**Volume 2
Work Plan
Phase 1, Task 4 Field Investigation**

**August 6, 1990
(reissued October 1991)**

COMMENTS ON VOLUME 2, WORK PLAN

Ohio EPA Comments - Volume 2, Workplan for Phase I Task 4 Field Investigation - (August 6, 1990)

Figure 2-2. Wright-Patterson Air Force Base map (Weston 1985)

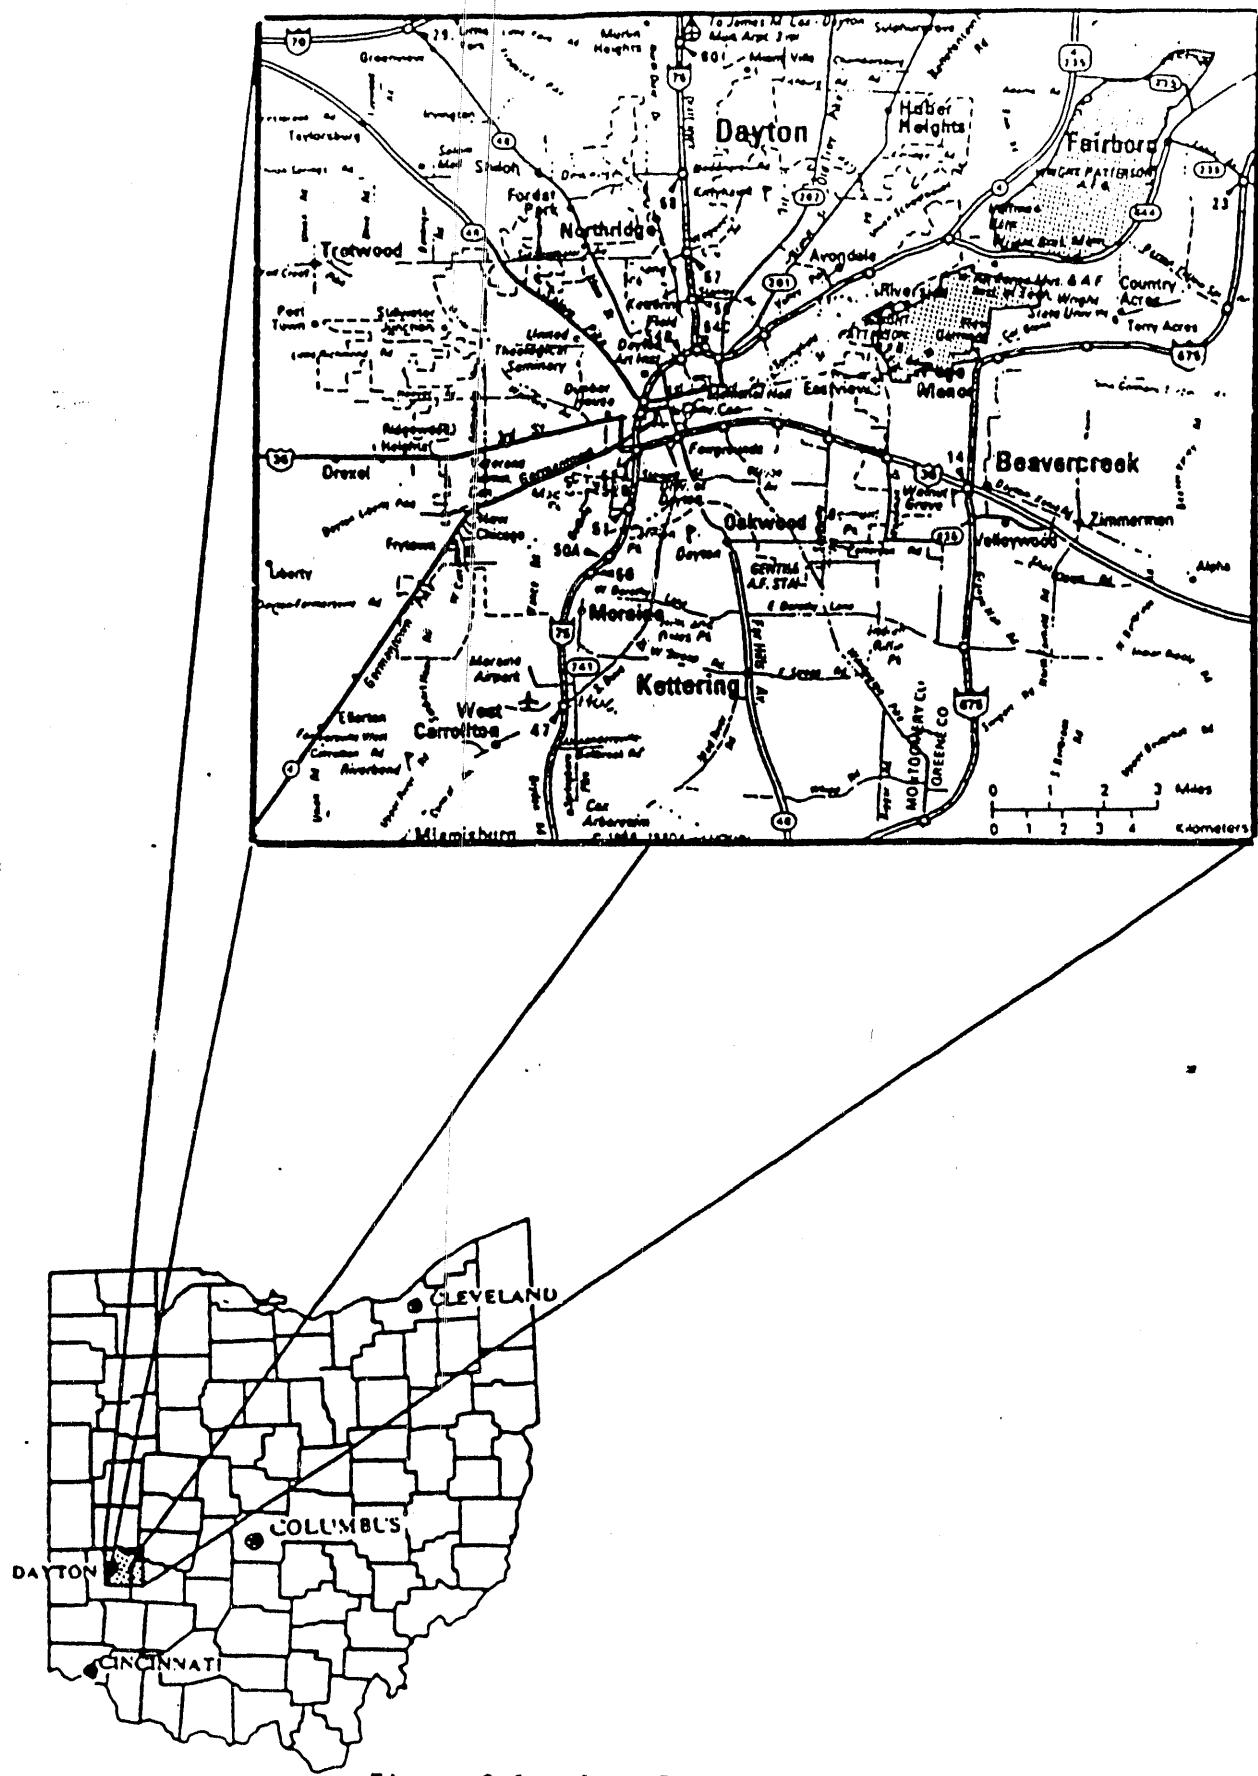
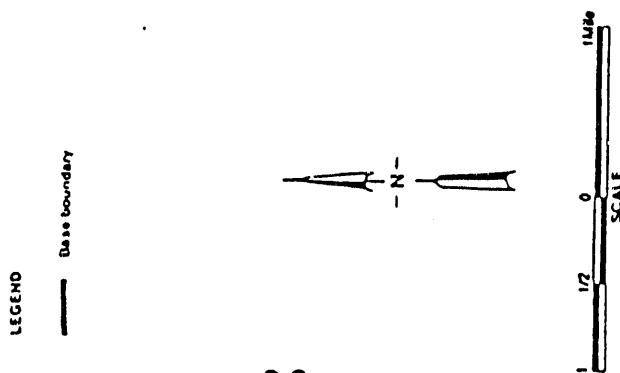
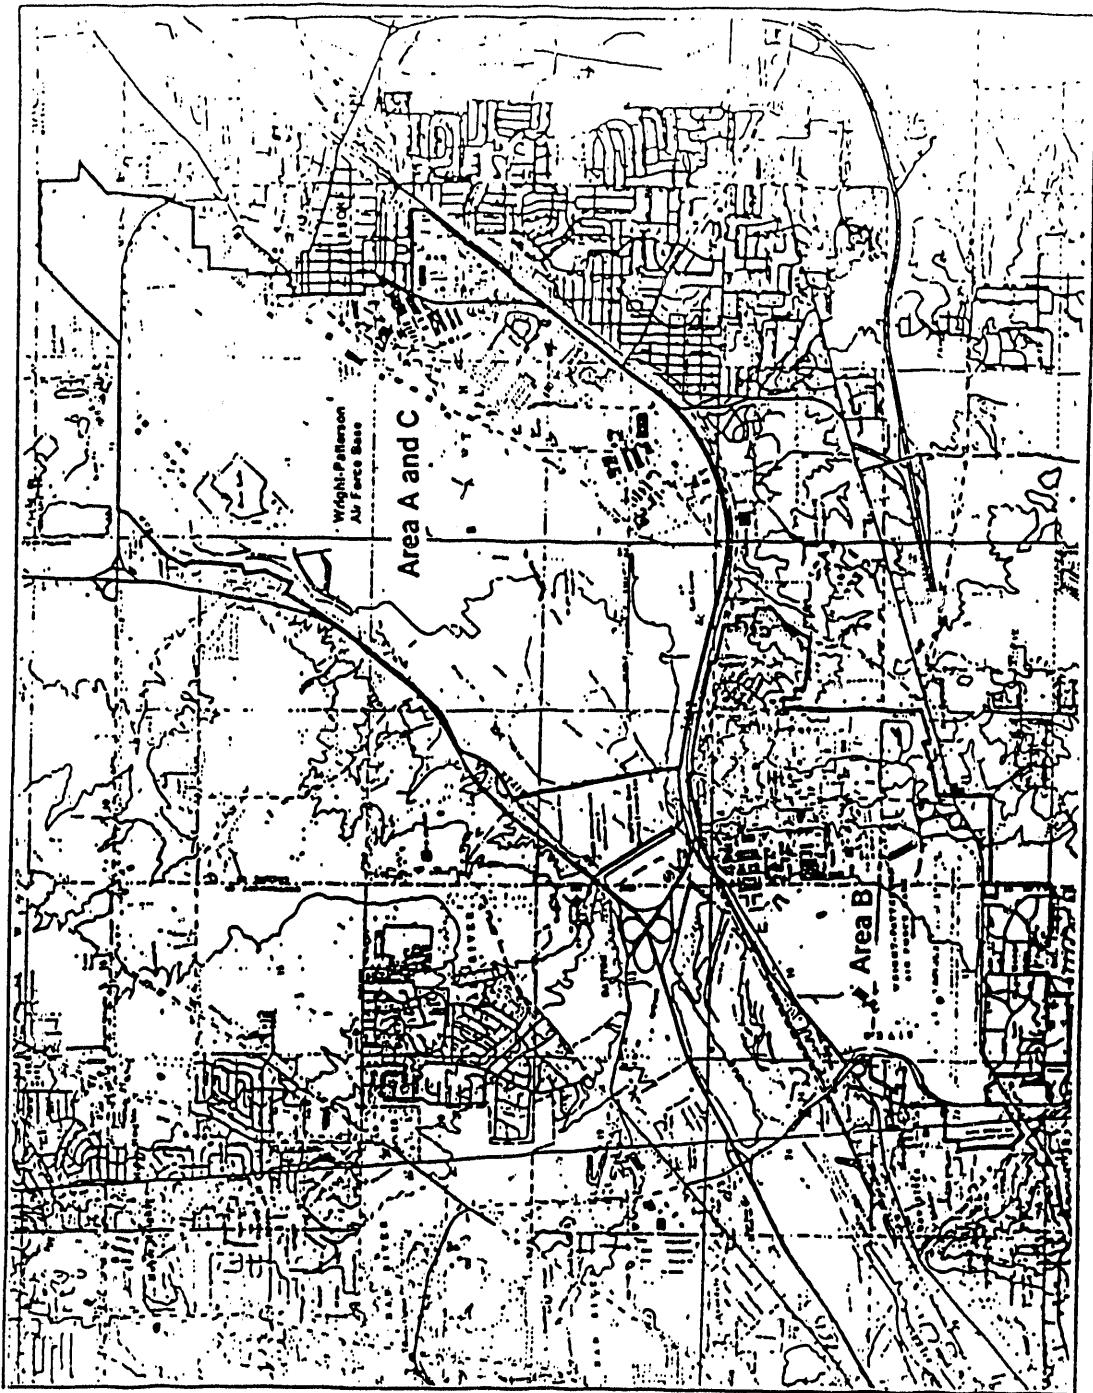
1. List of Acronyms: "DQA" should be "DQO". Also, "OEPA" should be added.
2. Section 2: Figures 2-1 and 2-2 are out of order.
3. Page 2-4, last paragraph: "product" should be "production" in the fourth line.
4. Page 2-5: This paragraph should be replaced with the following:

Figure 7-1. General Organization Chart.

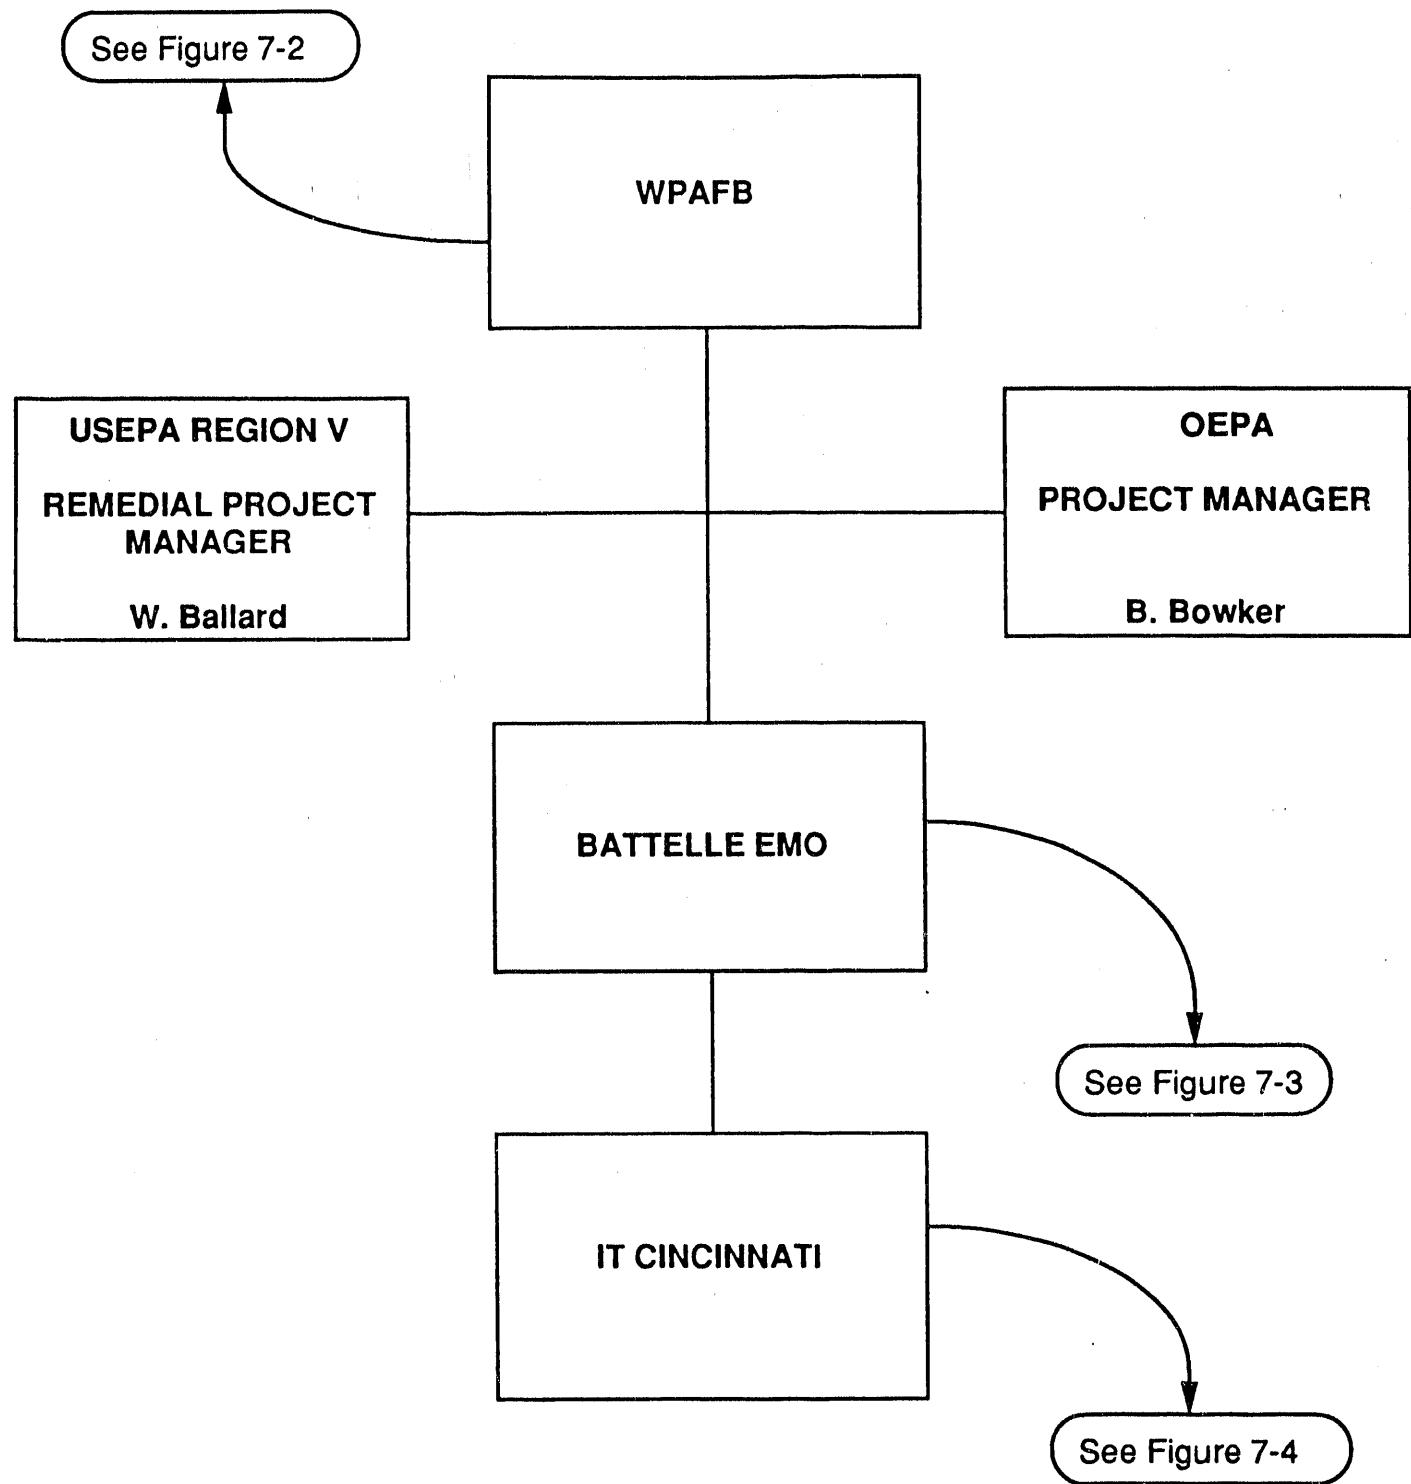
20. Page 4-17, Table 4-3: Include Carbon tetrachloride and Bromomethane in the TCL Volatile Organic Compounds.
21. Page 6-1, 6.0: Replace the phrase "back-end deadlines" with the phrase "project scheduling constraints".
22. Page 7-4, Figure 7-2: The names in this table are not current. Please update the table.
